PART 21 REPORT - DEFECTIVE MOTOR OPERATED POTENTIOMETER

Report No. 10CFR21-0117
Rev. 0: 06/09/17

10CFR21 REPORTING OF DEFECTS AND NON-COMPLIANCE

COMPONENT: Motor operated potentiometer without pre-position feature
P/Ns: 72-07900-100-ESI
2-04E-184-103-ESI
2-00G-009-002-ESI

Photo 1: Desired Return-to-Center Cam Arrangement

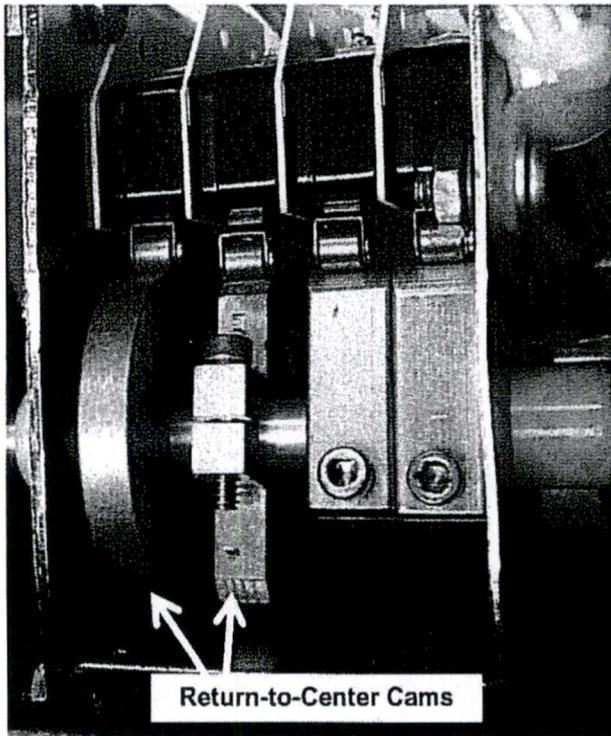
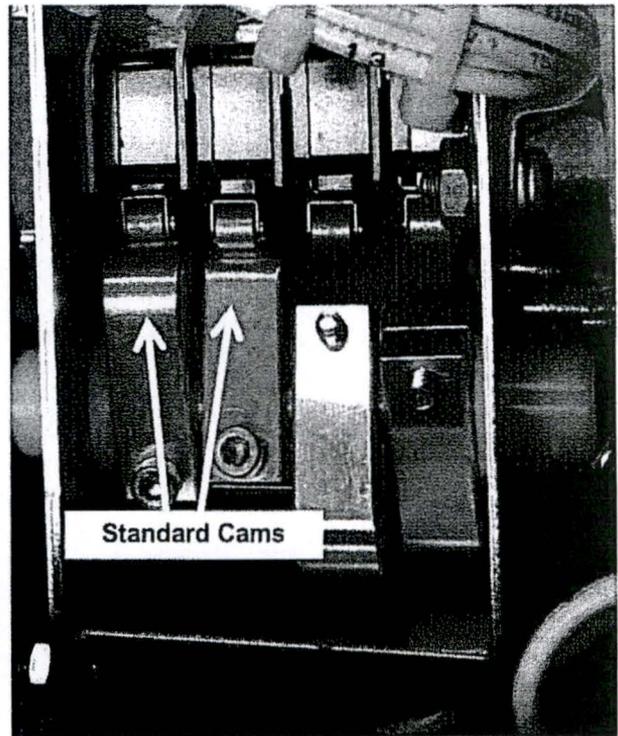
The Basler MOP selected by ESI for the assembly was model MOC2103. A review of Basler model MOC2103 indicates that it is not a return-to-center style device and instead contains a standard cam arrangement. Photos on the following page depict the differences between the two cam arrangement styles. ESI inadvertently selected the incorrect model for this application. Reviewing the qualification testing performed by ESI revealed that ESI's testing duplicated the original Portec test procedure (whereby one cam is set to close above setpoint and one cam is set to close below setpoint). However, the testing was shown to be inadequate to fully ensure the return-to-center functionality. Though the cams were properly set above and below setpoint, a further verification that the unit would return to center, even if sufficiently away from setpoint, was not performed. For installations that rely on the pre-position function, it is possible that the MOPs supplied by ESI would not return the potentiometer to setpoint. Since the MOP is used to set output voltage of the emergency diesel generator, the consequences of this issue are that the EDG may not maintain voltage within its required range to support its safety-related loads.

- To prevent recurrence of this issue, ESI is implementing a revision to the procurement process for this assembly to update the part number of the MOP utilized. In addition, the dedication inspection and testing activities are being revised to ensure testing properly validates the return-to-center feature. This action is currently underway and will be completed prior to any future shipments.

Photos 3&4: Return-to-Center Cam Profile & Arrangement

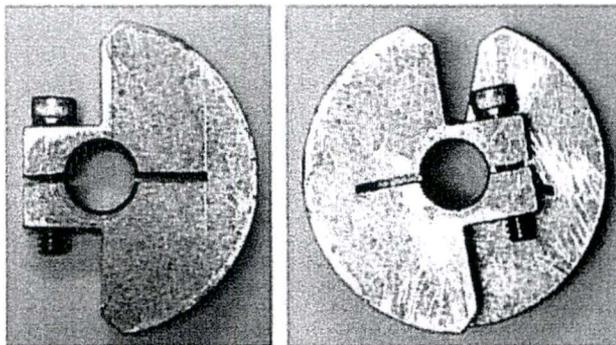
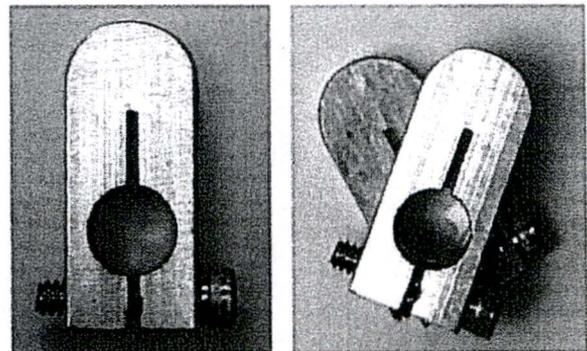
ESI selected the incorrect MOP to be used for this assembly. The original MOP used was an Portec/NEI P/N 72-07900-100 which became obsolete in the 1990s. ESI offered a replacement assembly (using the "-ESI" suffix) that included a Basler brand MOP, modified by replacing the factory supplied potentiometer to replicate the original Portec design. The original Portec MOP had the return-to-center feature and Basler offers some models with return-to-center and some without. ESI inadvertently selected the model without return-to-center.
